Roads and Maritime Service Project Manager
Sydney Harbour Bridge Southern Toll Plaza Precinct Upgrade
PO Box 609
Pyrmont NSW 2009

Re: BIKESydney's submission to the Sydney Harbour Bridge Southern Toll Precinct Upgrade

Cover page of Project REF indicating existing under-utilisation of southern end of Incident Response Operations Area. Rationalising the space would for the realignment of area's western boundary wall, which would create provision for the future cycleway.

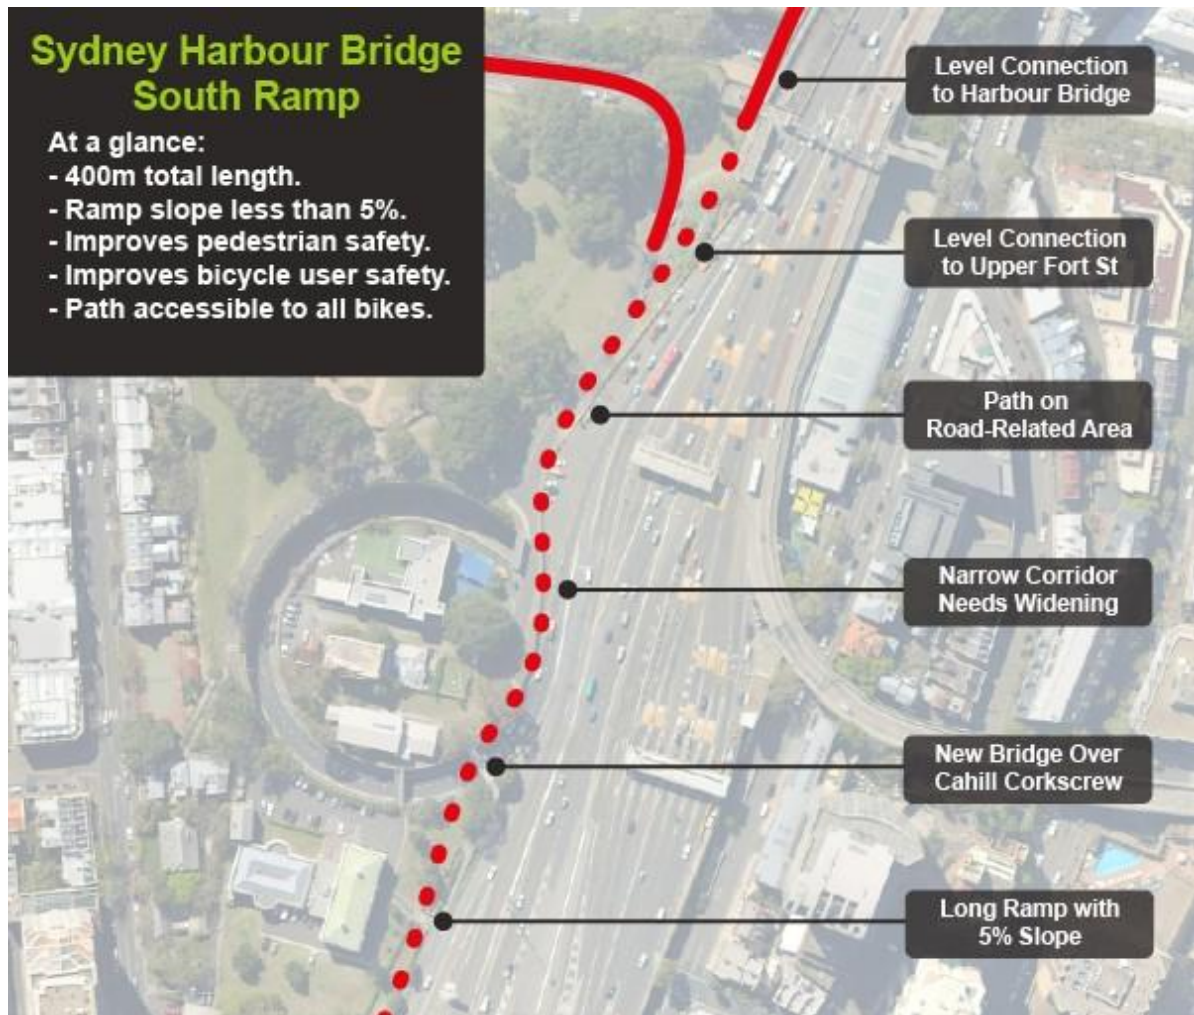
While the Upper Fort St roadway itself is controlled by the City of Sydney, the RMS controls the existing Harbour Bridge southern approach path, and critically, the footbridge over the Cahill Expressway corkscrew ramp and the motorway wall - the subjects of this submission. This motorway wall - presently demarcating the western boundary of the Project's Incident Response Operations Area - is to be retained in its current alignment, thereby potentially impinging on the space required for the upgraded cycleway.

BIKESydney requests that the Project re-align the western wall of the Incident Response Operations Area to make provision for the future cycleway path. The space request is very modest requiring only a minor relocation eastward of the most westerly point of the wall. Presently, this southern region of the existing Incident Response Operations Area is under-utilised and is often devoted to staff car parking. Even the cover page of the Project's own Review of Environmental Factors (REF) report indicates that there would not be a significant imposition on resuming a small amount of this space.
